APPLICABILITY: All 2014MY Forester, Impreza, XV Crosstrek, WRX, & STI Models

NUMBER: 05-57-14

SUBJECT: Front Cross Member Mounting Bolt Change

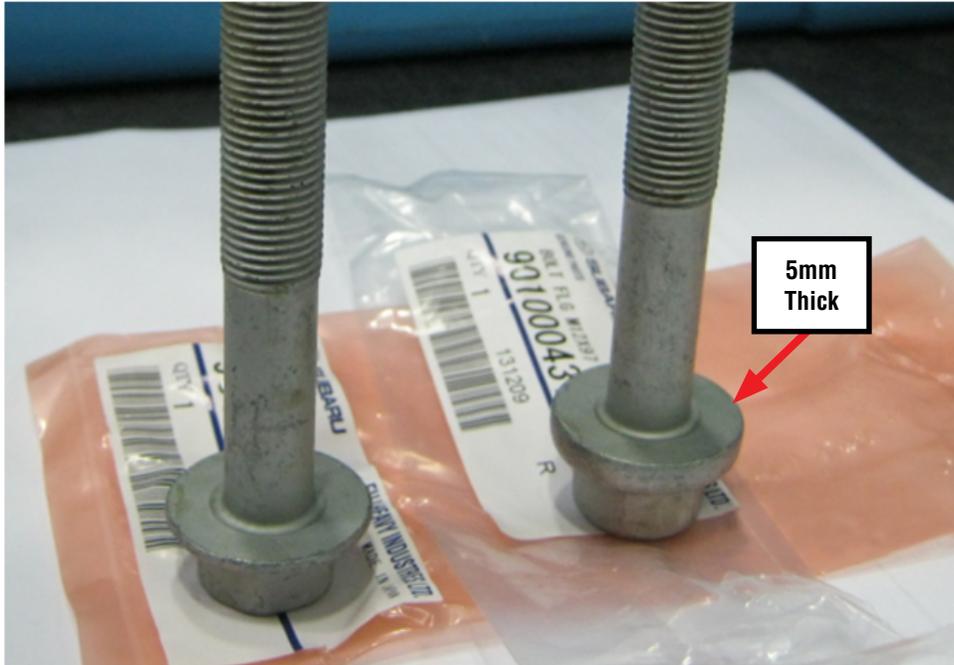
This bulletin describes a design change made to the mounting bolts used for securing the front cross member to the vehicle body. The flange thickness at the base of the bolt’s hex portion has been increased from 1.4mm to 5mm.

The old-style bolt is shown below, left and the new style with the 5mm thick flange is on the right.

PART NAME	PART NUMBER
BOLT FLG M12X97	901000431

- These bolts have been designed for front cross member mounting only and are not compatible for other use in other areas of the vehicle.
- These bolts are **one-time use** items.
- The torque specification for all models listed above remains unchanged and is 95 Nm / 70.1 ft. lbs.
